Errata to
Liquid Cooling Guidelines for Datacom Equipment Centers, Second Edition
(2013)

September 11, 2014

Figure 4.15 Immersion cooled datacom equipment in a liquid-cooled rack using a vapor compression system.

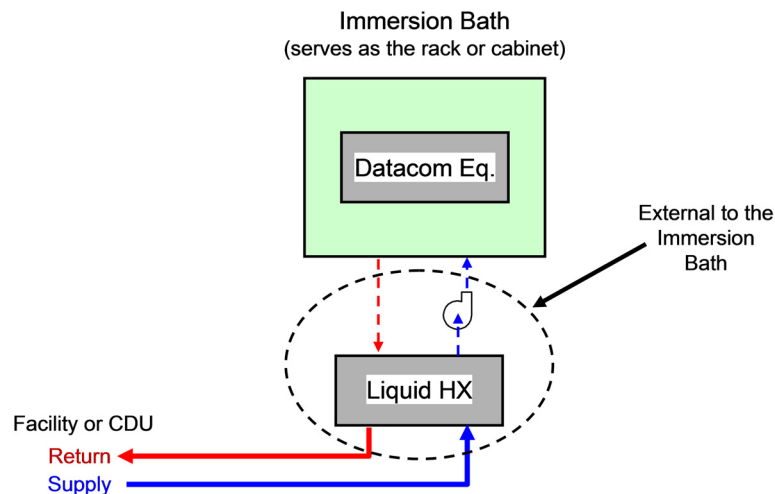
Page 51: Figure 4.15 is incorrect. The correct figure is below.

Figure 5.5 Location of CDU units in data center—Option 1.

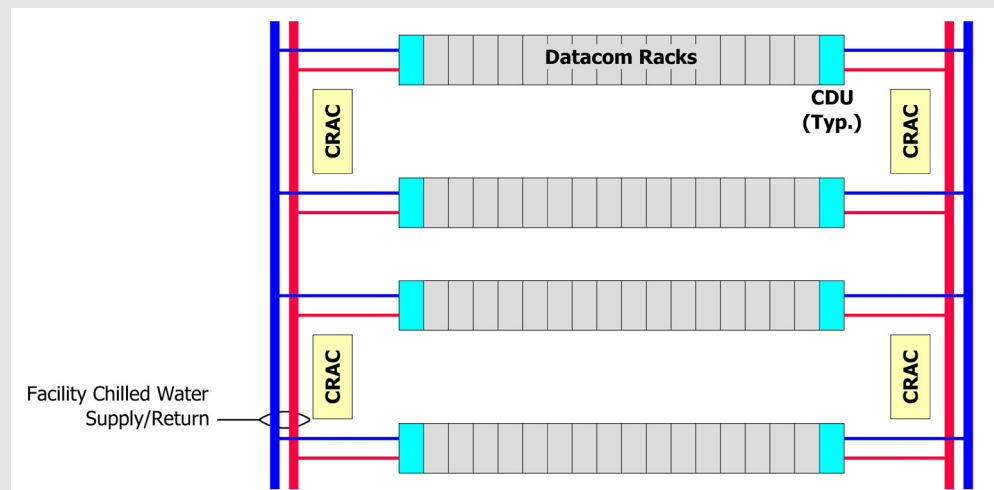
Page 70: Figure 5.5 is incorrect. The correct figure is below.

Figure 6.2 Water flow rates for TCS loop and for constant heat load.

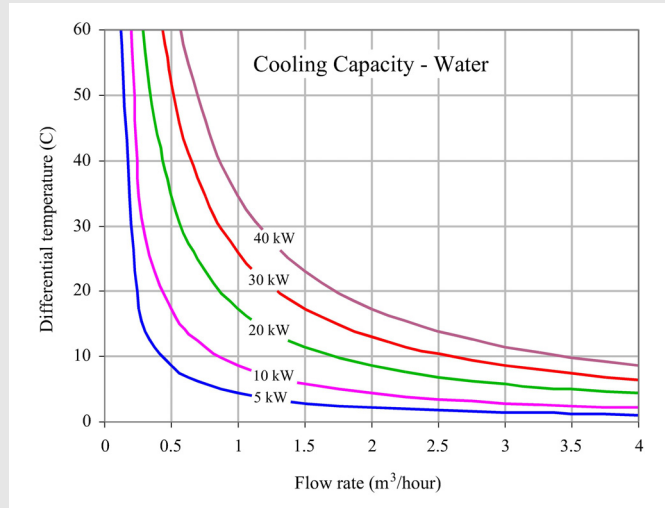
Figure 6.2 is incorrect. The correct figure is below.
